FOR **Proposed Coastal Protection
Works at Wainui Beach**

STATEMENT OF EVIDENCE (COASTAL IMPACTS)

Willem Pieter de Lange

1 February 2018

Figure 2 – Holocene tectonic sub-regions within Poverty Bay (Fig 2 – Brown, 1995), and the location of the GISB continuous GPS record at Patutahi.

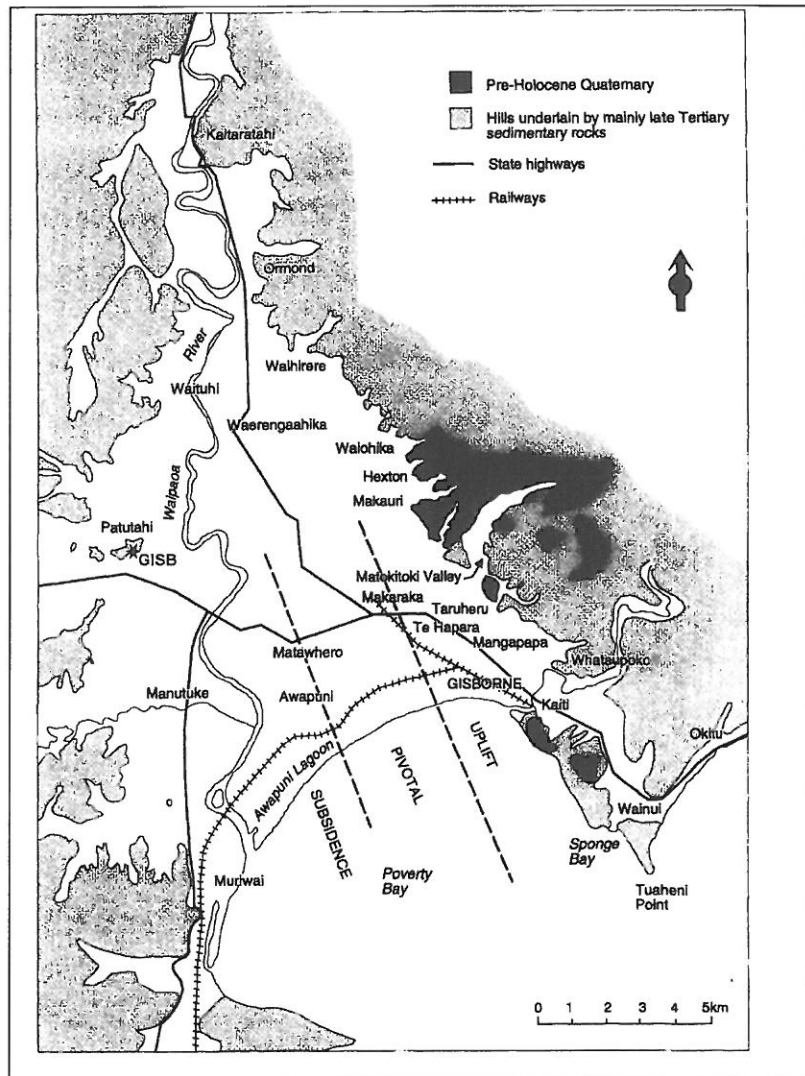
- assessed as extremely unlikely, and currently appears to be less likely than that.
21. However, my concern is the statement that Gisborne is stable to slightly subsiding ($\sim 1 \text{ mm.y}^{-1}$) used to justify using the upper end of the ranges of sea level for the design at Wainui Beach. This based on a report by Bevan and Litchfield (2012), which indicates that the trend for 10 years of continuous GPS data obtained at $38.6353^{\circ}\text{S } 177.8860^{\circ}\text{E}$ is $-1.1 \pm 0.6 \text{ mm.y}^{-1}$. The site is located near Patutahi inland from Gisborne, and not on the coast (Figure 2).

23. Geological evidence indicates Poverty Bay has been tilting during the Holocene (Brown, 1995), with northern area of Poverty Bay uplifting and southern area subsiding about a central pivot region (Figure 2). The continuous GPS record analysed by Bevan and Litchfield was obtained on the southern subsiding side of the inferred pivotal zone. Wainui Beach occurs at the northern end of the uplifting zone and is associated with the highest rates of uplift. The rates of uplift are discussed in my site visit report, but range from $1\text{-}3.2 \text{ mm.y}^{-1}$ during the Holocene. The properties in Tuahine Crescent are located on estuarine sediment similar to the exposures at Sponge Bay, and suggest $>10 \text{ m}$ of uplift over the last 8,000 years.

24. Given the evidence for uplift, in my opinion it is not reasonable to assume the upper limits of global sea level rise for the potential relative sea level change at Wainui Beach. Although instrumental sea level data are available for Gisborne, the measurements at the Port are affected by river discharge, which will reduce their reliability. Therefore, it is difficult to derive a historical sea level trend for Gisborne. Hence, in my opinion, the lowest MfE values are probably the best indicator of future sea level, and preferable to the highest values. However, given the uncertainties in the CIMP5 projections,
